From: William Clogan <WClogan@regenesisis.com>
Sent: Friday, August 20, 2021 2:50 PM
To: Grittner, Paul V - DNR
Subject: RE: Questions regarding Kenosha Engine Plant Injection Proposal
Attachments: F5- KEP Post soil remediation storm water basins.pdf; Former KEP New Storm Water Pond As-Built.pdf

Subject: RE: Questions regarding Kenosha Engine Plant Injection Proposal

FORMER KENOSHA ENGINE PLANT

FINAL AS-BUILT POST REMEDIATION FALL 2019

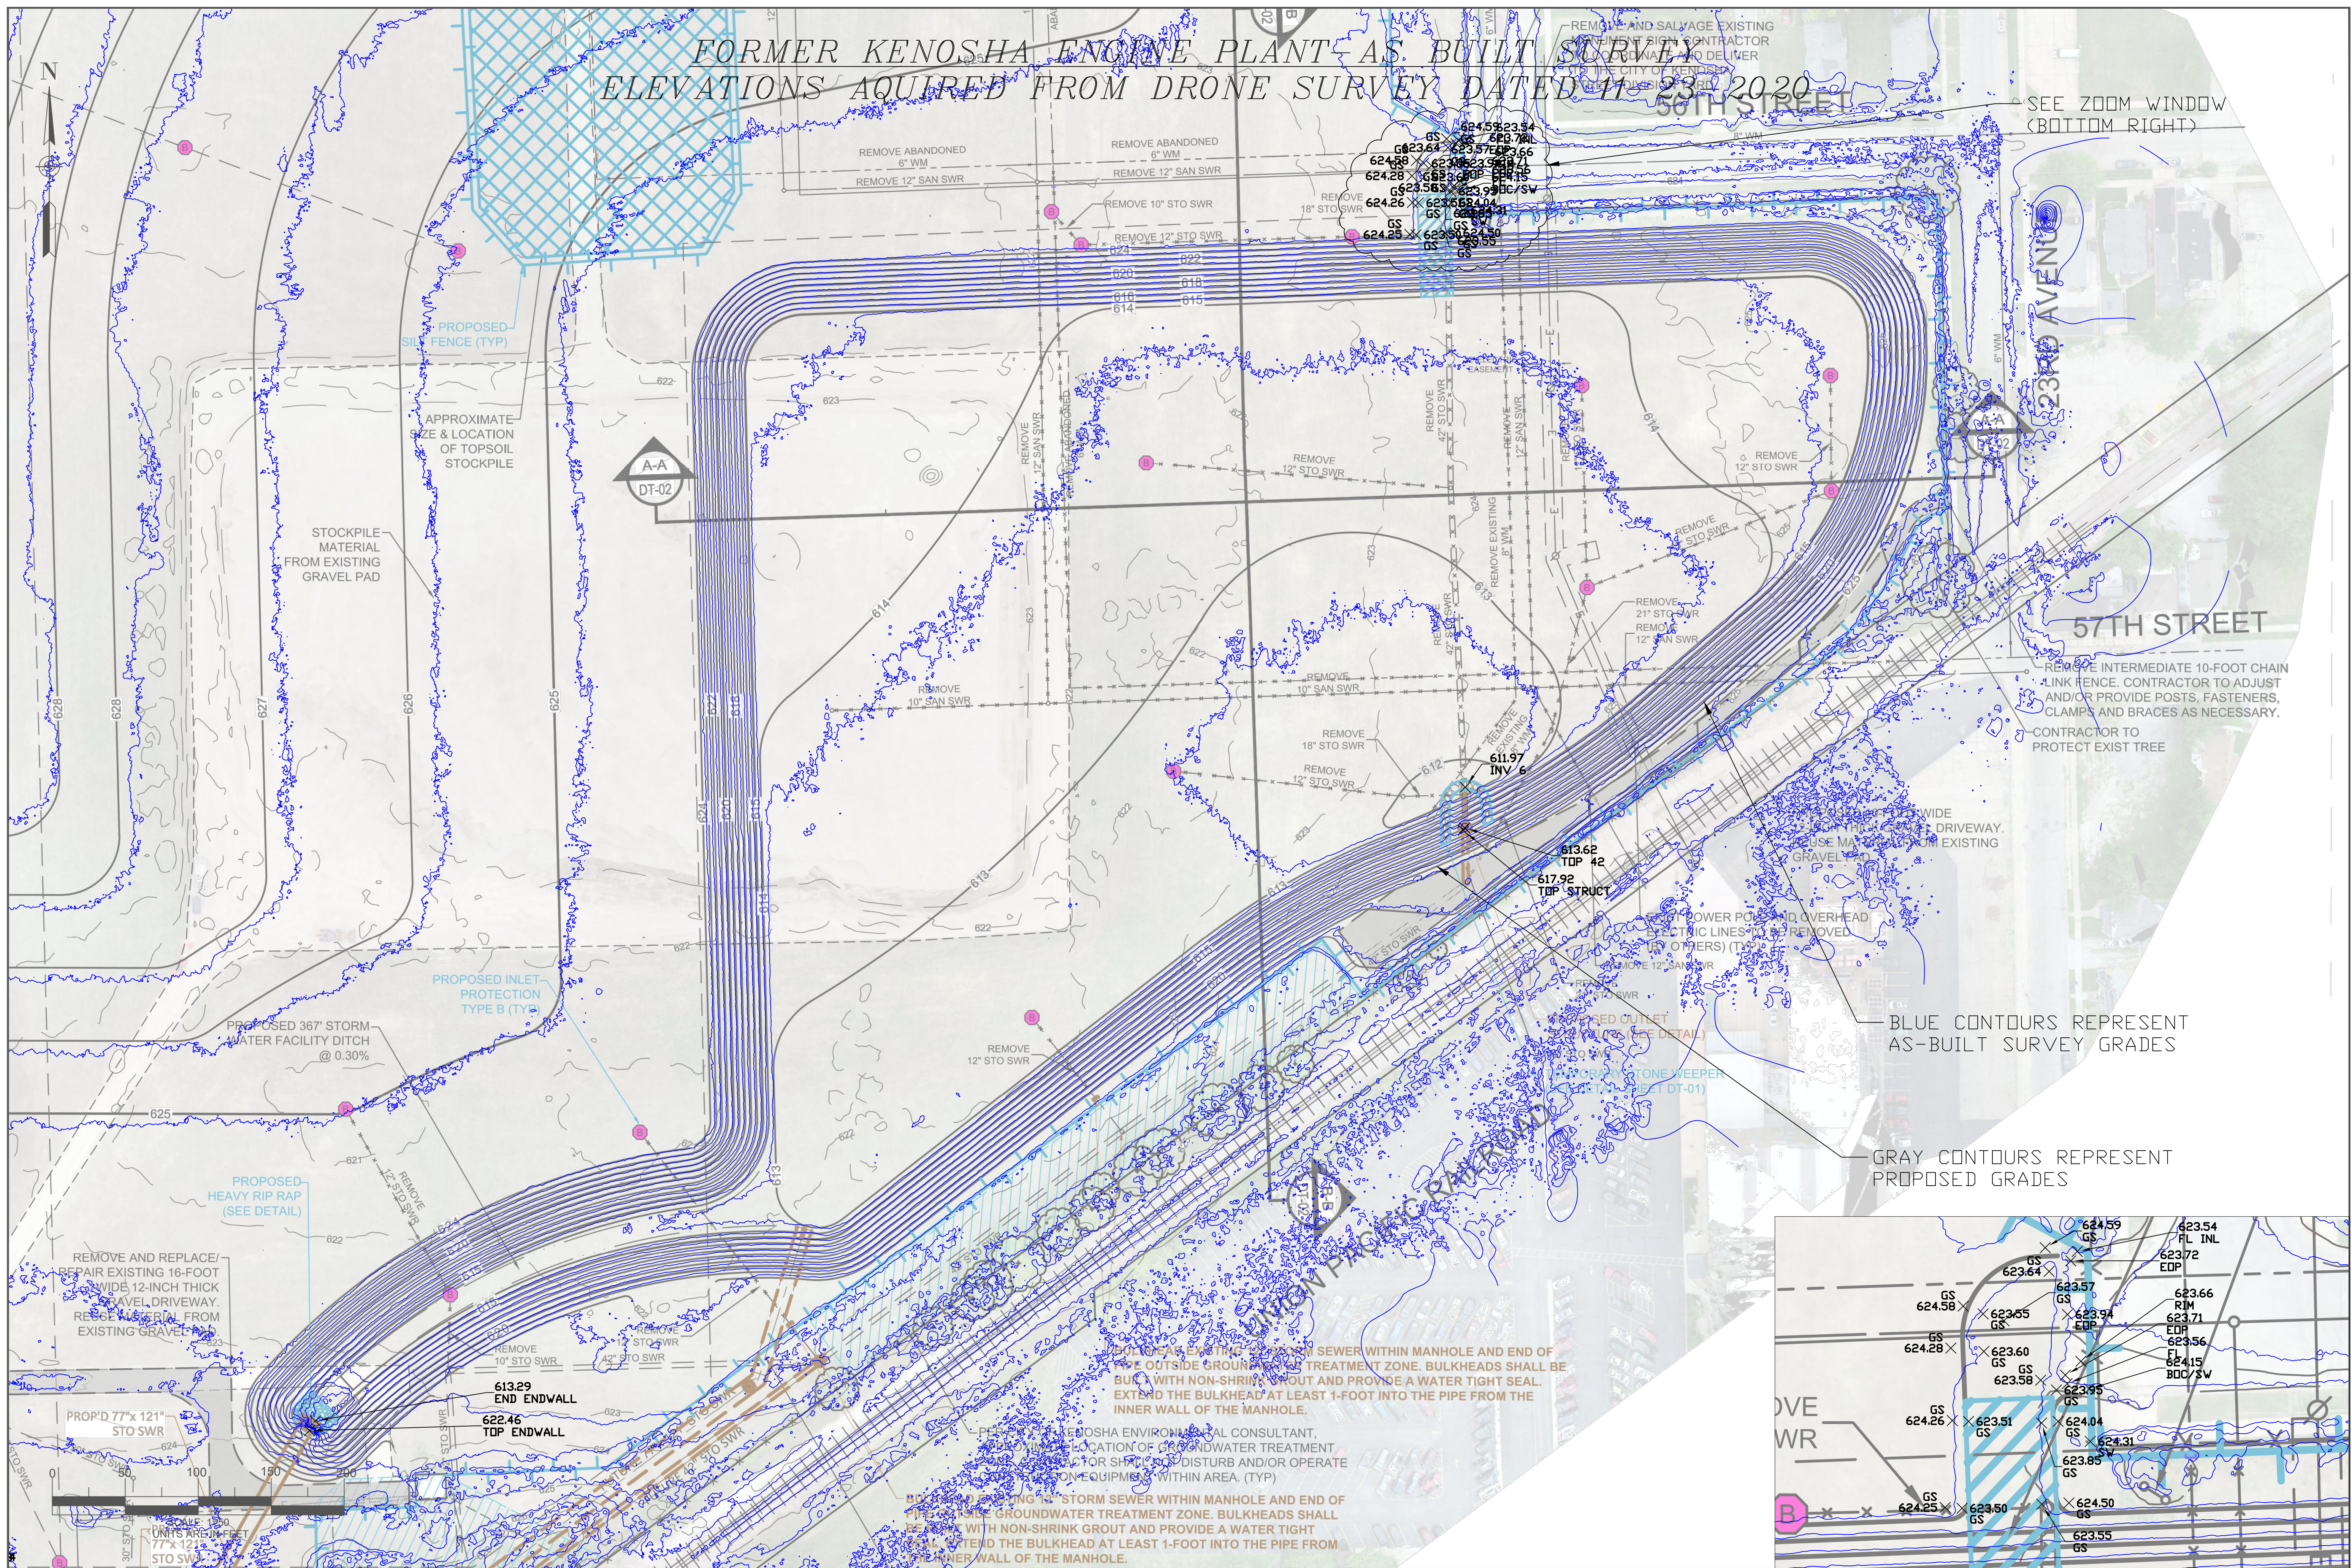
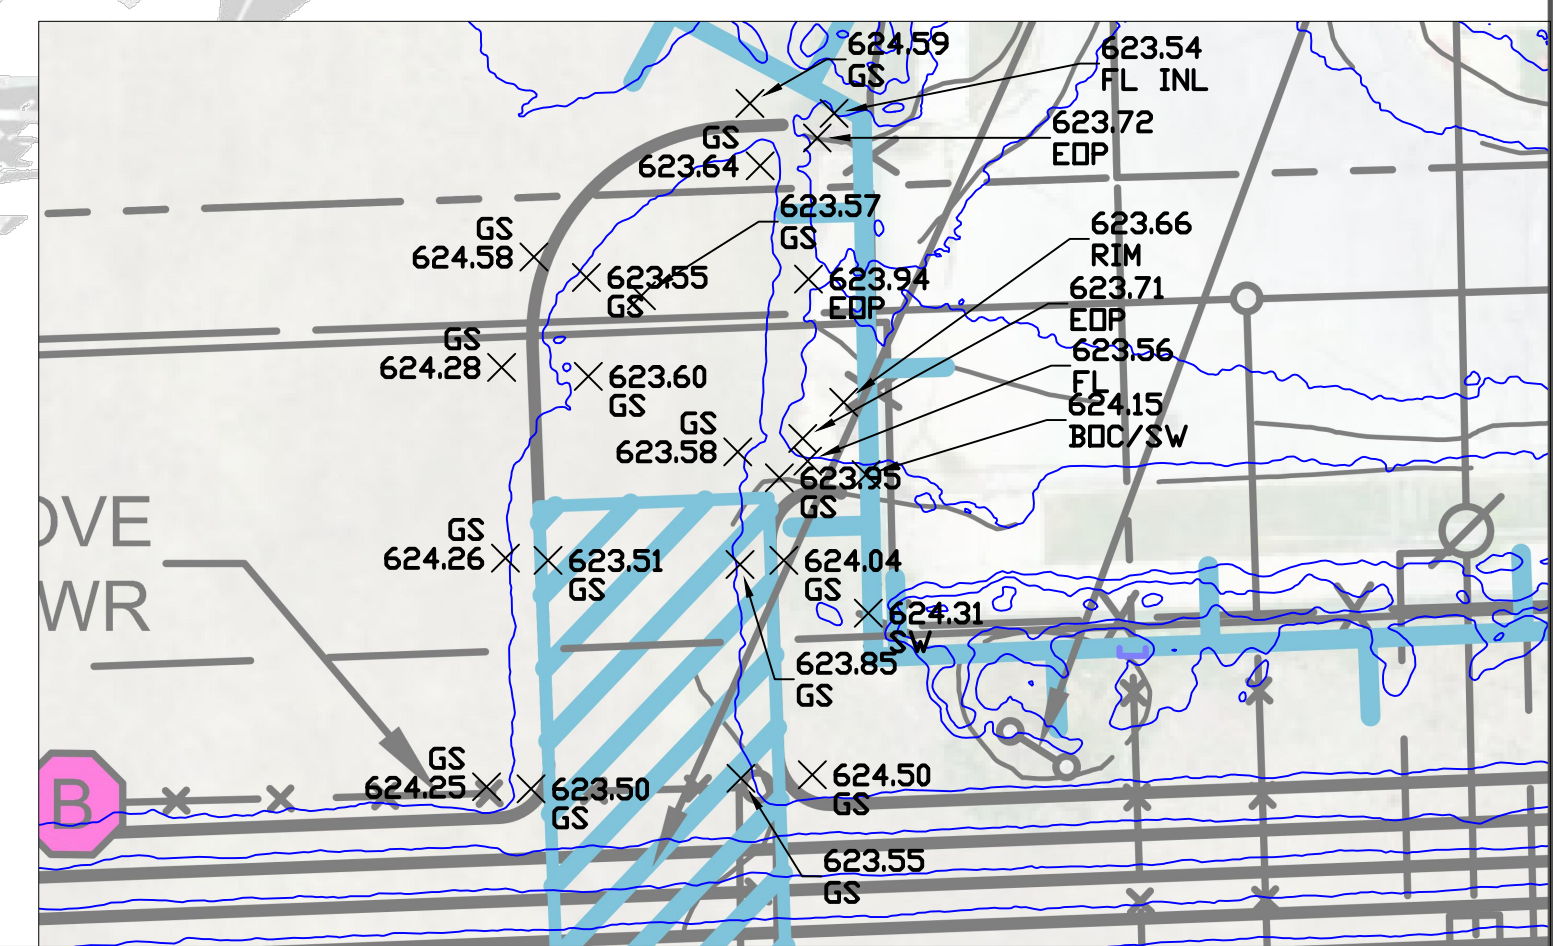
Where are the sewers located that will be accessed, how and when will they be monitored?

A temporary storm sewer network was installed as part of soil remediation and is connected to the existing storm sewer main line that extends northward to 52nd Street or southward toward 60th Street depending upon the location within the KEP. These storm sewers are shallow and observations can be made at the storm sewer inlets depicted on the **attached storm sewer map**. There is no sanitary sewer network on the KEP. The sanitary sewers were capped at the property boundary at the time that the bankruptcy liquidation trust demolished the buildings.
